CITY OF ALBUQUERQUE

**RE: Montgomery Crossing
8810 Montgomery Blvd NE
Grading and Drainage Plan
Engineer's Stamp Date: 08/22/2025
Hydrology File: G20D054
Case # HYDR-2025-00309**

Based upon the information provided in your submittal received 9/8/2025, the Grading and Drainage Plans are approved for Grading Permit, Paving Permit, and Building Permit. Please attach a copy of this approved plan in the construction sets for Building Permit processing along with a copy of this letter.

GRADING PLAN
 MONTGOMERY CROSSING

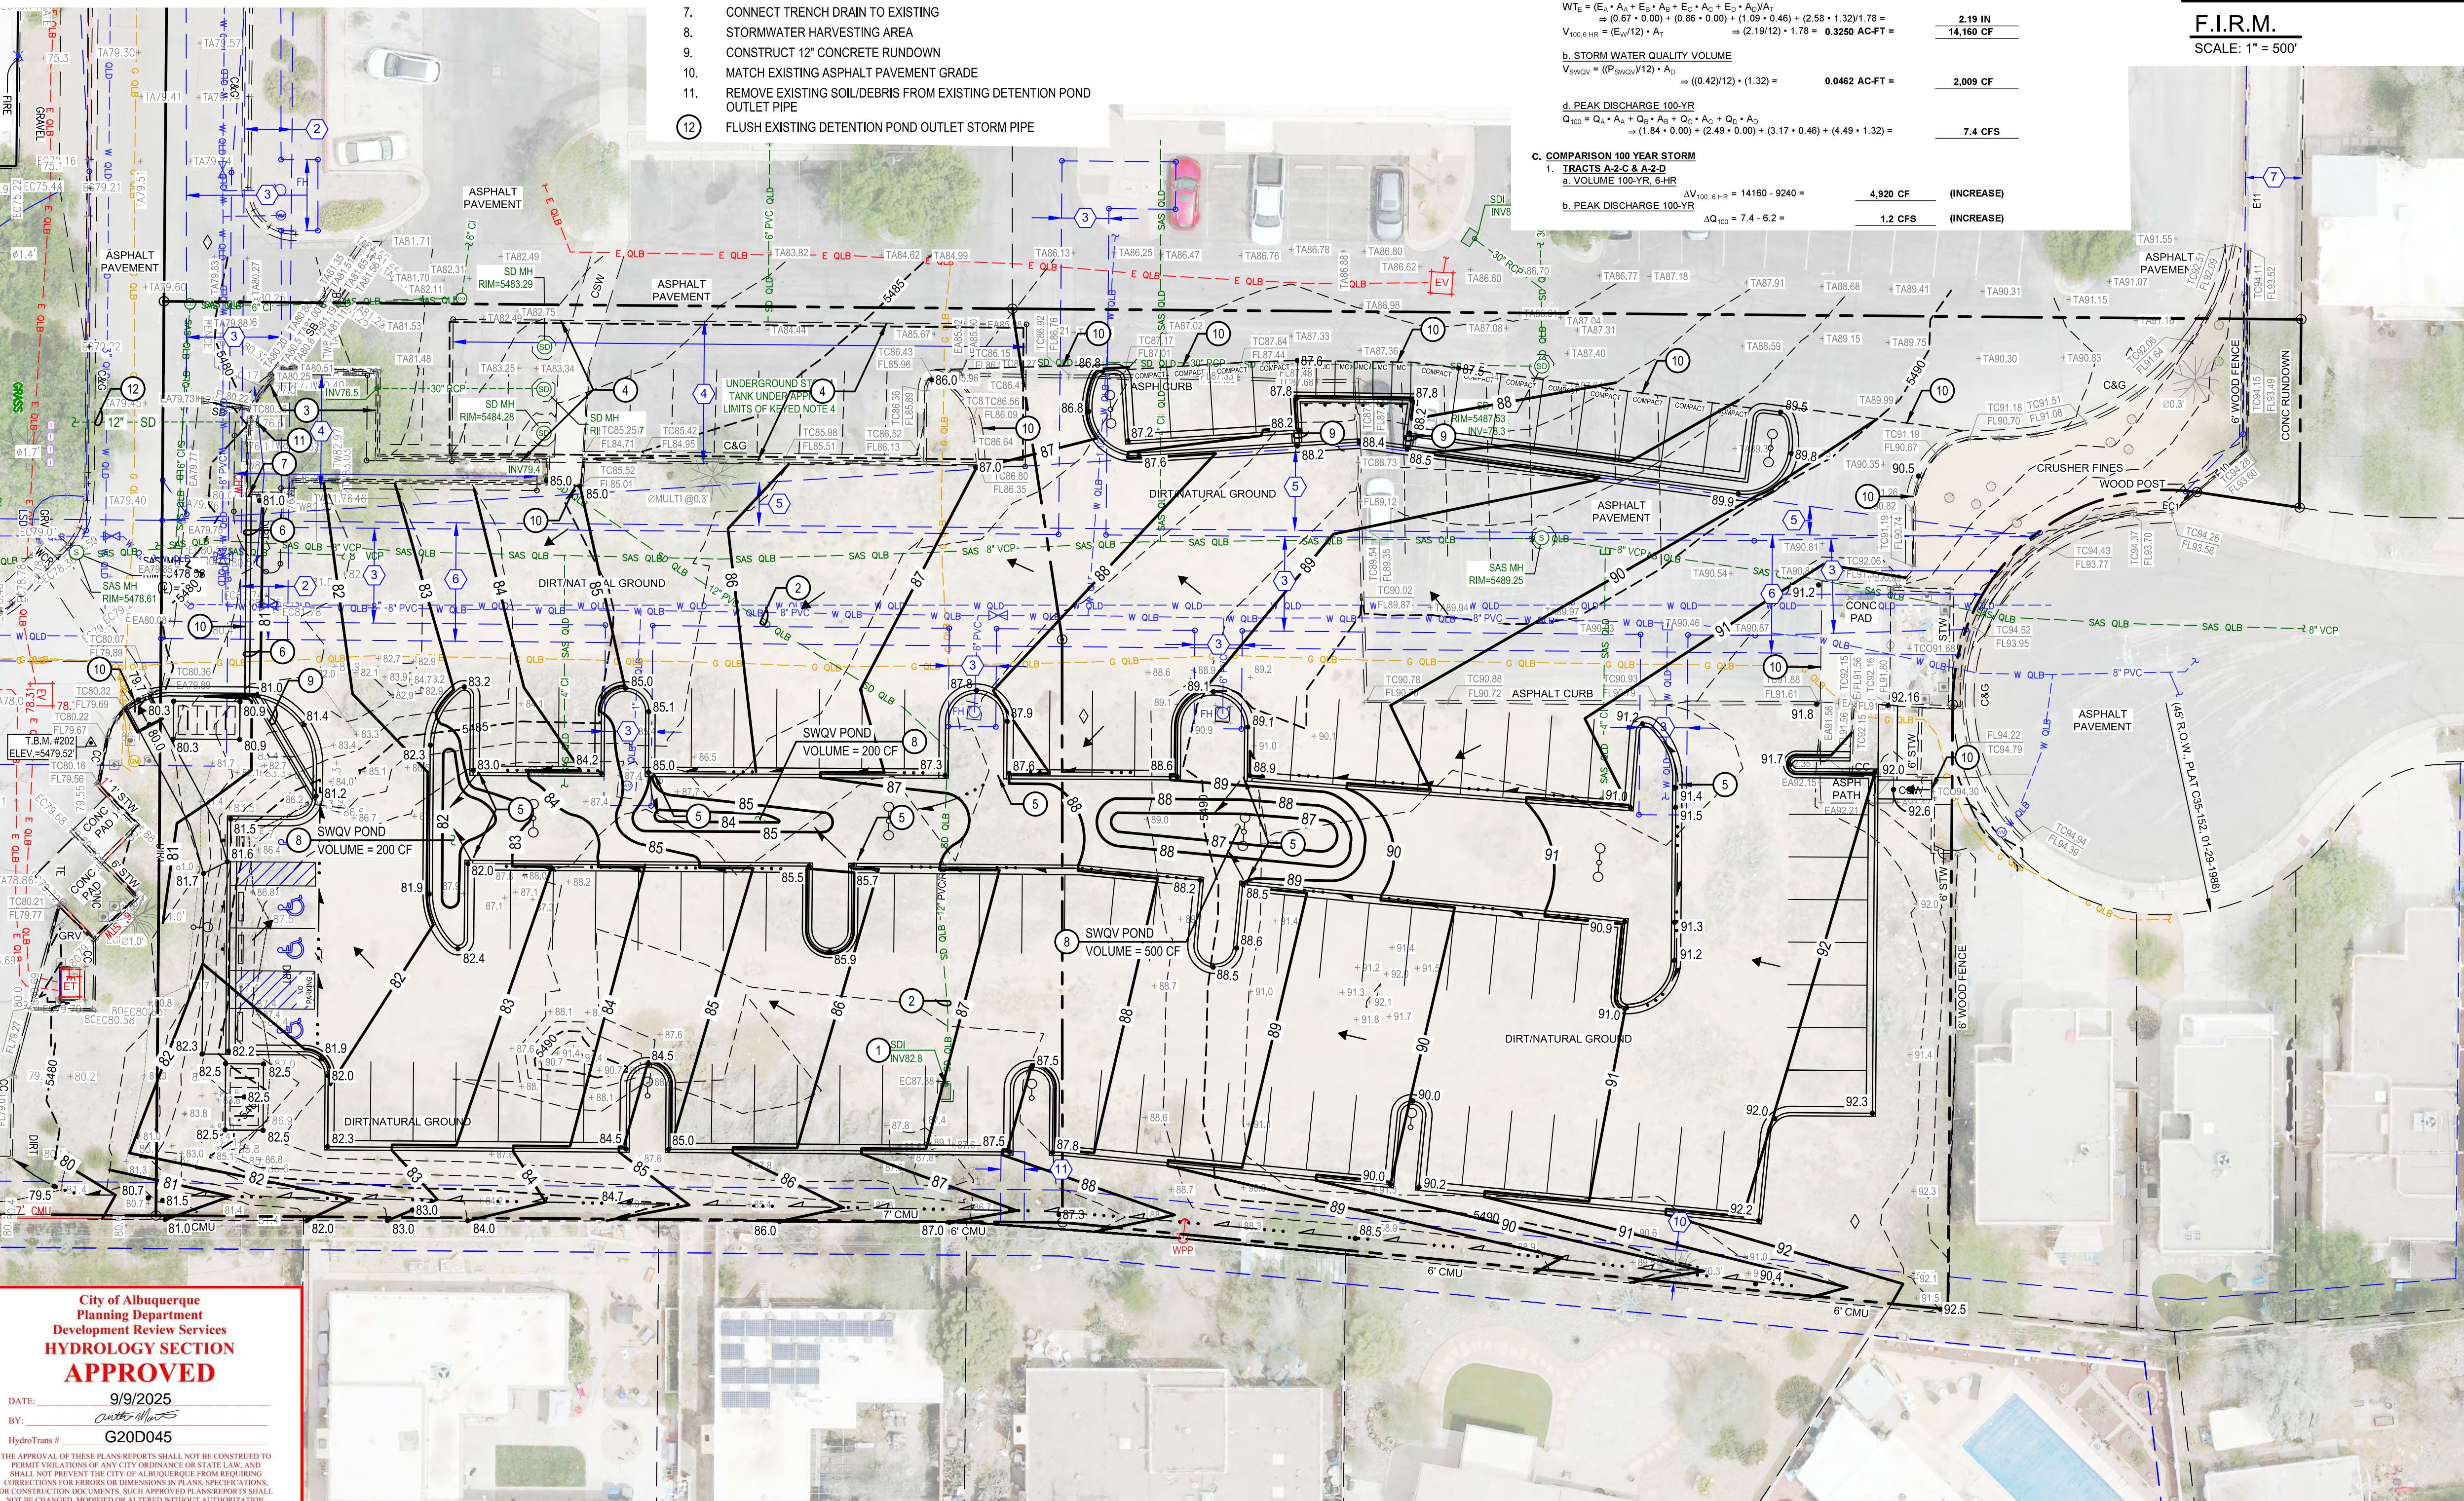
1. Engineer's Certification, per the DPM Part 6-14 (F): Engineer's Certification Checklist For Non-Subdivision is required.

As another reminder, if the project total area of disturbance (including the staging area and any work within the adjacent Right-of-Way) is 1 acre or more, then an Erosion and Sediment Control (ESC) Plan and Owner's certified Notice of Intent (NOI) is required to be submitted to the Stormwater Quality Engineer (Doug Hughes, PE, jhughes@cabq.gov, 924-3420) 14 days prior to any earth disturbance.
